CITY OF NOVI CITY COUNCIL JUNE 17, 2024

SUBJECT: Consideration of the request of E & M Holdings, LLC, (Society Hill) to

amend the 2001 Consent Judgment, and to set a public hearing on the

The City's staff and consultants reviewed the latest proposal and provided written comments to the applicant on May 2^{nd} . Since that time, staff has met with the applicant and discussed many of the issues raised in the review letters. As a result of that discussion, and additional information provided by the applicant, staff has taken the opportunity to revise and update the initial review letters, as follows:

Overview of the potential hillslope wetland identified in **Attachment B**. Also identified in comments as Potential Missed Wetland 3.

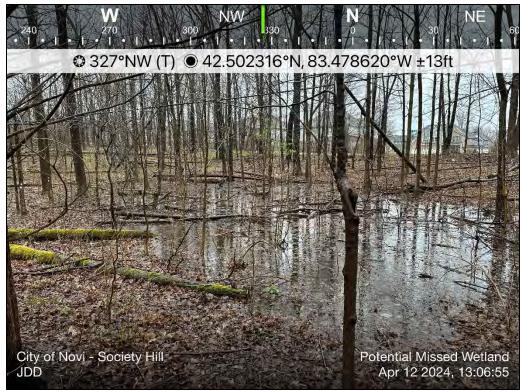
Overview of the potential southeastern wetland missed identified in **Attachment B**. Also identified in the comments as Potential Missed Wetland 4.

Stream/swale draining from Potential Missed Wetland 3.

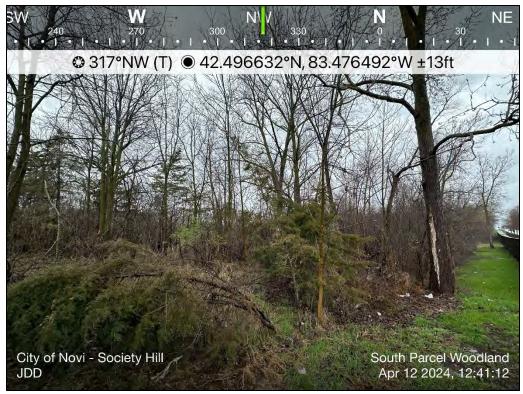
Stream/swale draining from Potential Missed Wetland 3.

Tree tags at the southern parcel match the tree survey provided in the PSP. Tree tag 1974.

Overview of Potential connection between Wetlands C, D, and B (as identified in the comments). Area is near what is identified as Wetland E on sheet two.

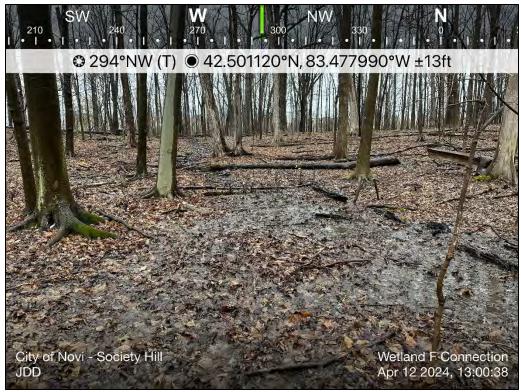
Overview of Potential connection between Wetlands C, D, and B (as identified in the comments). Area is near what is identified as Wetland E on sheet two.

Overview of Potential connection between Wetlands C, D, and B (as identified in the comments). Area is near what is identified as Wetland F on sheet two.

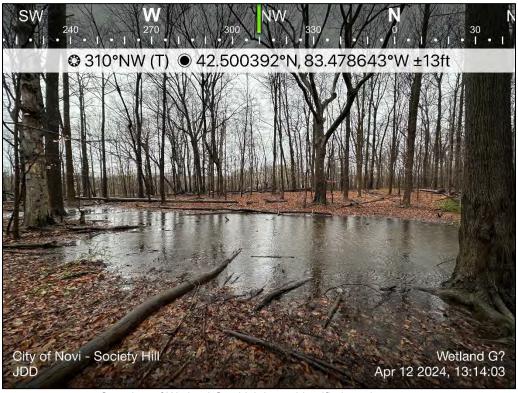
Overview of Potential connection between Wetlands C, D, and B (as identified in the comments). Area is near what is identified as Wetland F on sheet two.

Overview of Wetland G, which is not identified on sheet two.

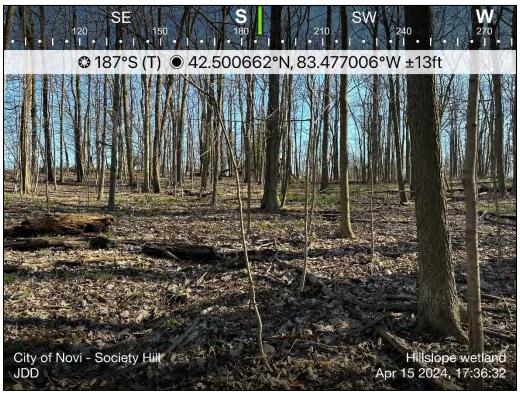
Overview of Wetland D (Wetland F on sheet two).

Overview of the central portion of the site. None of the trees in this area contained tree tags/markings.

Potential Wetland Extension (as identified in comments).

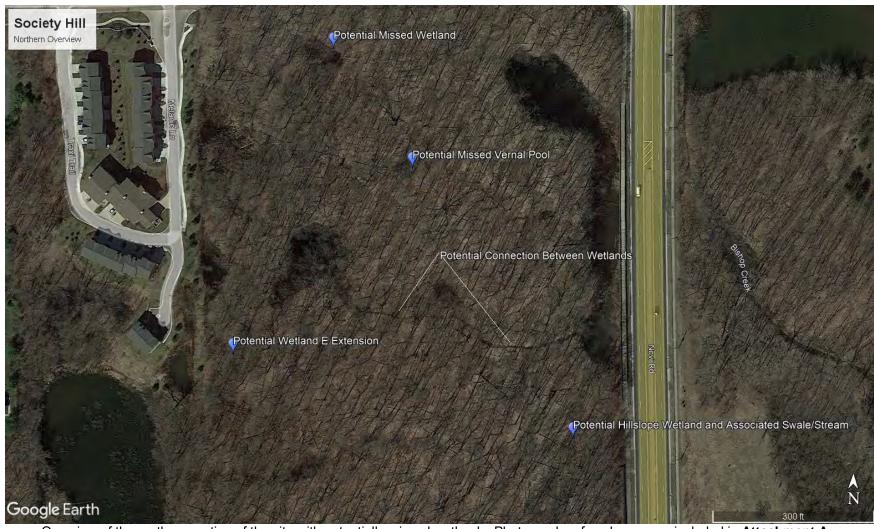
Overview of Potential connection between Wetlands C, D, and B (as identified in the comments). Area is near what is identified as Wetland E on sheet two.
